Unified Indoor Tactical Recon Robotic System

RELEASE NOTE

FIRMWARE GCS MkII v3.3.2

July 2024

/ Region Selection

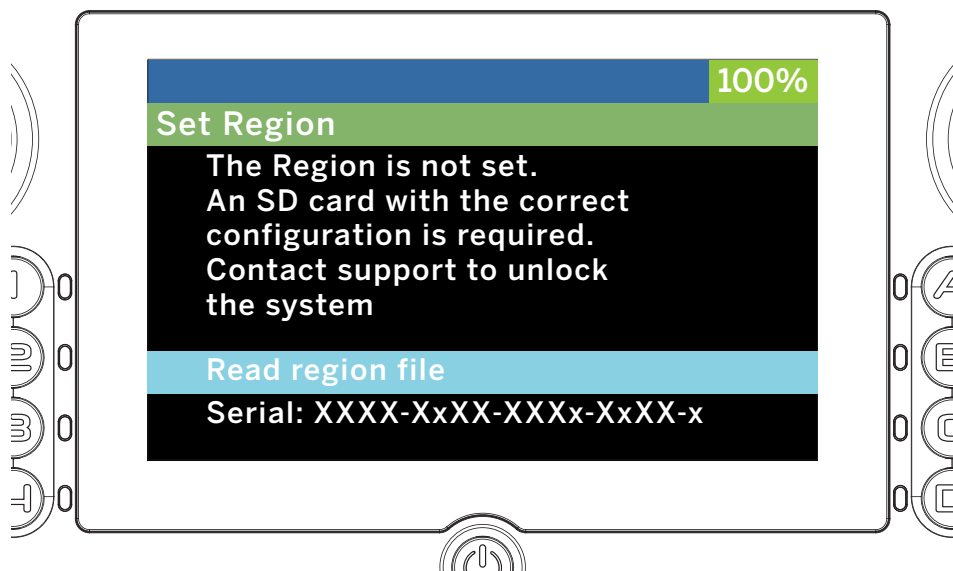
The region selection process on the GCS MkII has undergone significant restructuring to ensure compliance with regulatory requirements, particularly aligning with FCC waivers in the United States of America. Users can no longer set the region by directly choosing FCC or CE options. Instead, access to specific regions now requires users to upload a region-specific code file via a Micro-SD card onto the GCS MkII.

There are 4 regions that can be configured now:

- FCC compliant
- FCC open
- CE compliant
- CE open

The open variants remain identical to the previous CE and FCC configurations. Users can continue to toggle between open and compliant settings as before. Existing customers upgrading will automatically transition to the open version corresponding to their region, ensuring zero disruption to their current usage. New customers will configure their region using the file provided by AXON.

To unlock to the GCS MKII, upload the file into a Micro-SD card formatted with FAT32 (compatible with cards up to 32GB). Insert the Micro-SD card into the designated slot on the GCS MkII and proceed to select the option «Read region file».

/ Bootloader

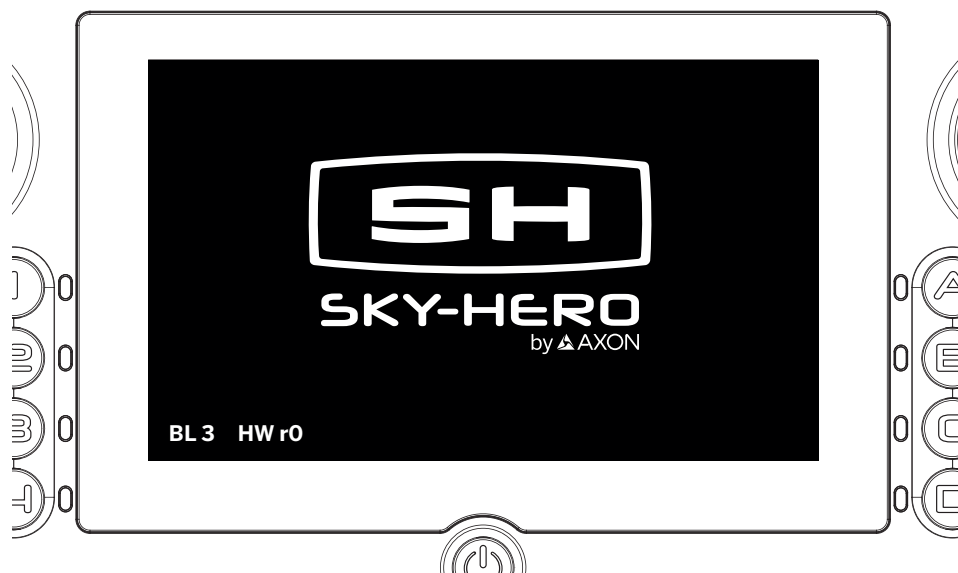
The latest release of the GCS MkII introduces an upgraded bootloader, significantly enhancing the system's capabilities. This engineering-driven update effectively doubles the available internal flash space for the firmware. In previous releases, we were compelled to remove infrequently used or non-critical features to accommodate new functionalities.

Starting from version 3.3.0, each GCS MkII update will necessitate the inclusion of two files:

- **The bootloader updater** (e.g. gcs-blu.131.bin)

- **The application** (e.g. gcs_app-3.3.0.bin)

This is the actual GCS MkII firmware. You can note that the name has changed from gcs-x.y.z.bin to gcs_app-x.y.z.bin for technical reasons.

If you have successfully installed the new bootloader, it will show the SKY-HERO by AXON logo at startup of the GCS MkII and the bootloader version in the lower left corner. It should show BL 3 for this version.
